180507297 Addendum to PB# 180423283 Acquisition of Sigma Designs Z-Wave Products

Bulletin Issue Date: 5/7/2018

Description of Change

Silicon Labs Acquires Sigma Designs Z-Wave Products

f) Marking change - SD3502A-CNE3R

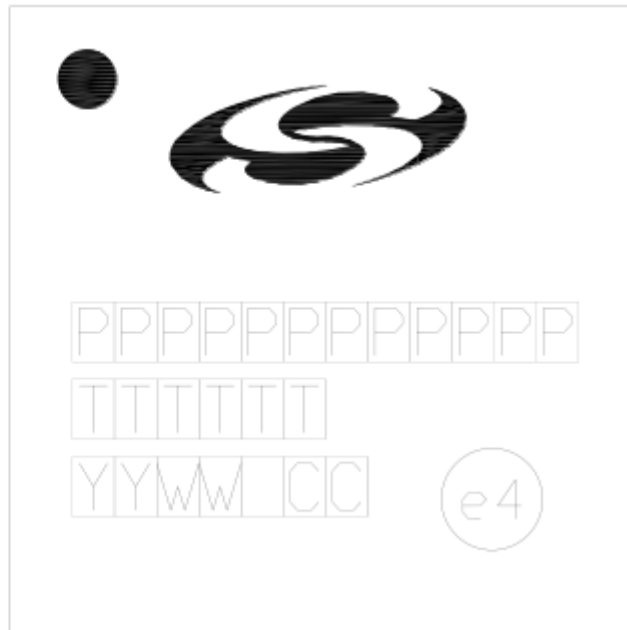
This Addendum is being issued to PB#180423283 to include Z-Wave top marking format changes for SD3502A-CNE3R, SD3503A-CNE3R, ZM5101A-CME3R and ZW0301A-CNE1 to Silicon Labs' format. Please refer to Appendix for details.
